DEC COMMENT No. 1:

DEC Comment No. 16 on the December 2014 Flushing Creek LTCP:

Figure 2: Area near DC-5

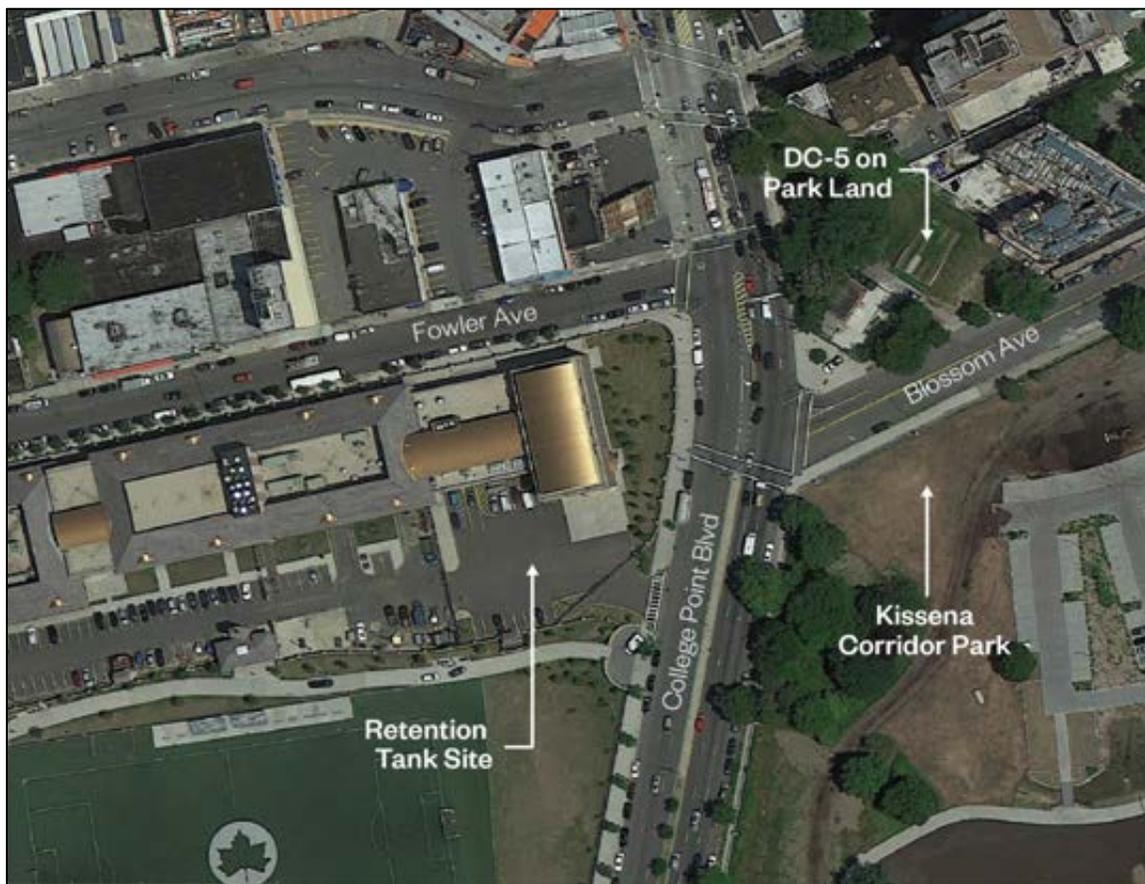
Evaluate the installation of an underflow baffle at Diversion Chamber 5 for floatables control.

One option considered the installation of a new baffle chamber upstream of DC-5 to allow for construction of a long enough baffle to maintain hydraulic neutrality. Siting a new baffle structure upstream of DC-5 would pose considerable challenges (see Figure 2). The existing sewer already traverses Blossom Avenue and there is limited space between the existing sewer and College Point Boulevard, a heavily travelled road. There is significant underground infrastructure in the area and nearby properties are either already developed or are park land. Encroachment on adjacent properties would likely be required to provide sufficient weir length. Excavation would be close to 40

feet deep and require extensive excavation support to protect existing sewers and the Lawrence and Peck PS. In addition, installing baffles in or immediately upstream of DC-5 is not the optimal location for this technology. Once wet weather flows subside, floatables would settle out at a baffle either in or adjacent to DC-5. Some of the floatables would likely remain settled, until either they are flushed out the next time the gates in DC-5 are opened to relieve high flows, or until they are removed manually. The floatables that are resuspended during the next event would be washed under the baffle before the water surface rises enough for the baffle to retain the floatables. These floatables could then be flushed over the weir (closed sluice gates in DC-5), causing what was retained previously to be discharged to Flushing Creek. Because of these issues, installing an underflow baffle in a separate chamber upstream of DC-5 is not considered viable.

Figure 4: Section of TI-R51

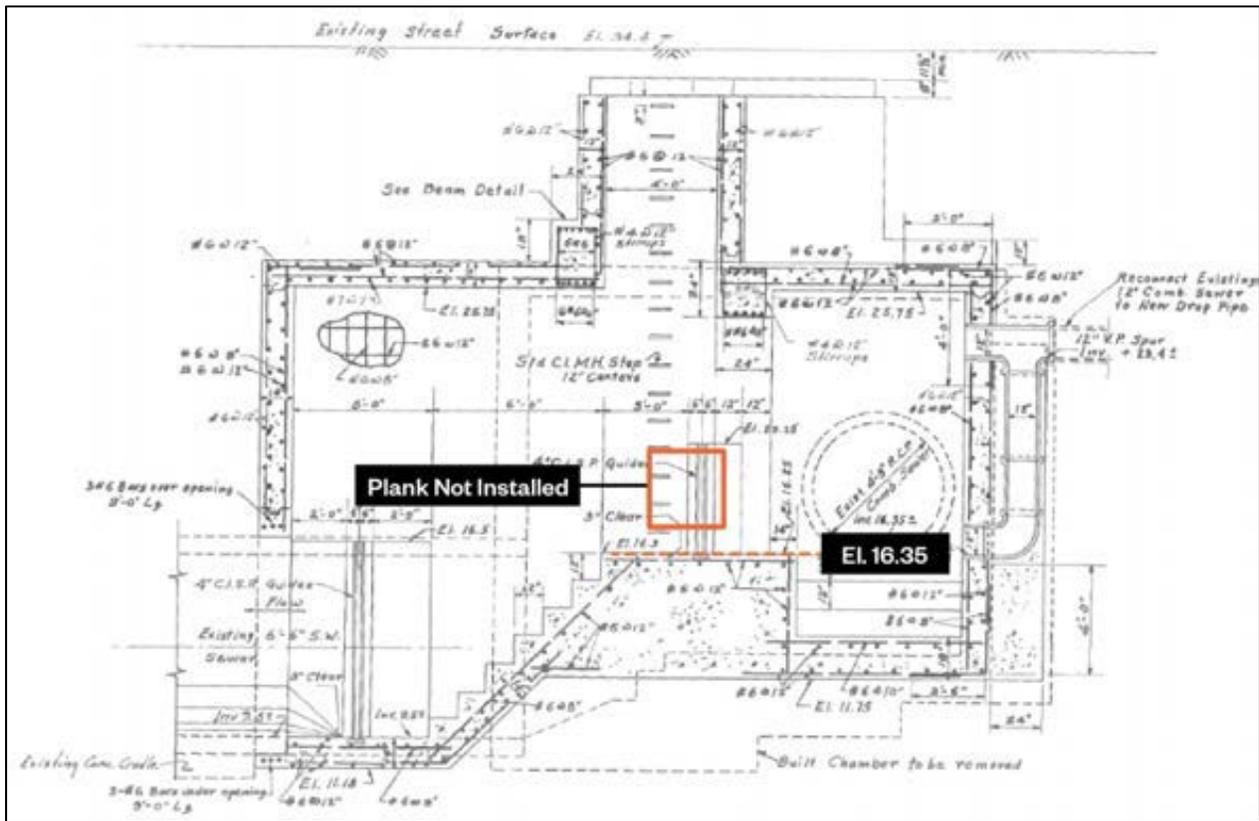
Evaluate floatables control at TI-011 and confirm that feasibility for including floatables control as part of the selected alternative.

*The original construction drawings of TI-R51 show that the existing structure has a 78-inch overflow line, with a 7-footwide, cast-iron, stop-plank weir. However, a review of the model and the DEP's Regulator Database indicate that the stop plank is not installed (see Figure 4). As such, the control elevation is at the invert of the control structure and modeling indicates that a baffle would adversely impact the upstream HGL. Additionally, any baffle would need to be installed along the top of the dry weather flow channel and not perpendicular to the flow, which is required for floatables capture. **Installing a baffle within TI-R051 is not feasible.***
